**PLANNING BOARD MEMO • MAJOR SITE PLAN • SKETCH PLAN REVIEW**

RE: #25-05 – Major Site Plan – Smith Cemetery Expansion – 513 Gray Road – Final Plan Review –  
Town of Windham  
Planning Board Meeting & Public Hearing: September 22, 2025

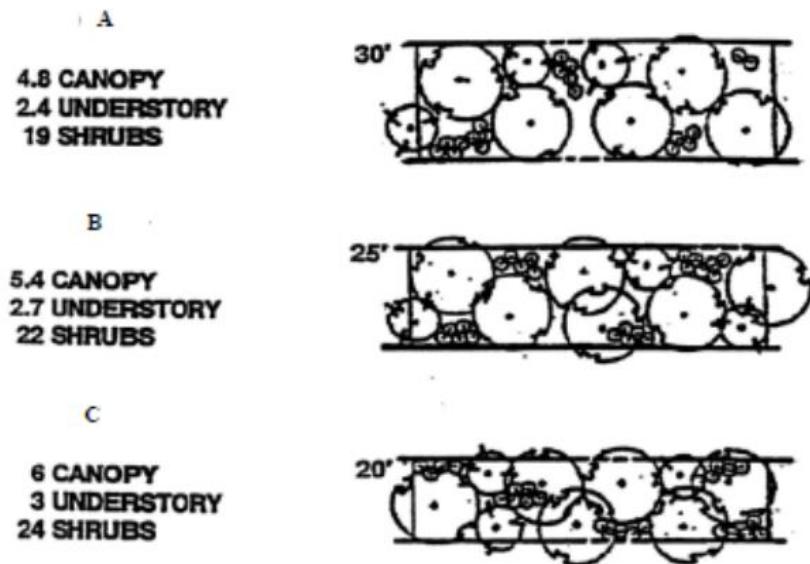
- [C\(3\)\(b\)](#) WC District buffer along streets: use Buffer Yard G, see exhibit below.
